37/03-04H 7700 Takoma Ave Takoma Park Historic District

HISTORIC PRESERVATION COMMISSION STAFF REPORT

Case Number: 37/03-04H

PROPOSAL:

PHOTO 2: EXISTING OF PROPOSED STAIR LOCATION DOOR TO REPLACE CENTER WINDOW

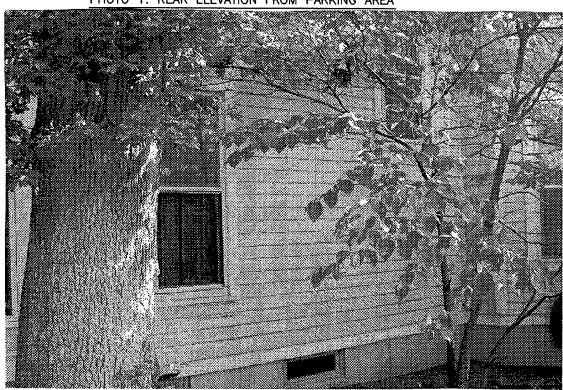
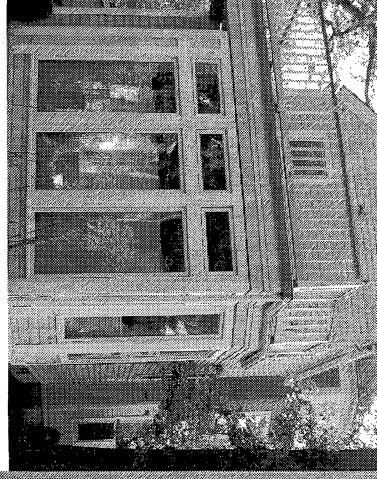
1) Installation of a new wood staircase on the side elevation (New York Avenue side). An original window would be replaced with a glass door. Proposed above the door is a painted white wood canopy with a ridged metal covering on top to create a covered

Staff has two main concerns with this proposal:

- 1) The removal of an original window from an Outstanding Resource, something which is discouraged and often denied by the HPC
- 2) All proposed changes are visible from the public right-of-way.

The alterations and additions on the New York Avenue side of the house will have an effect on the house as well as the streetscape. These changes do not affect the front elevation of this house and the rear of the house has already been altered with the 1980s addition. Should a future owner want to remove the stairway some day, if the removed window was kept on-site, perhaps the original window could be re-installed. The design of the canopy over the new side door could perhaps be made more compatible with the historic character of the building and staff would like to work with the architect on this element of the proposal.

1) The new walkway will be brick.

2) The architect will work with staff on a new design for the canopy over the new side door that is more compatible with the historic character of the building.
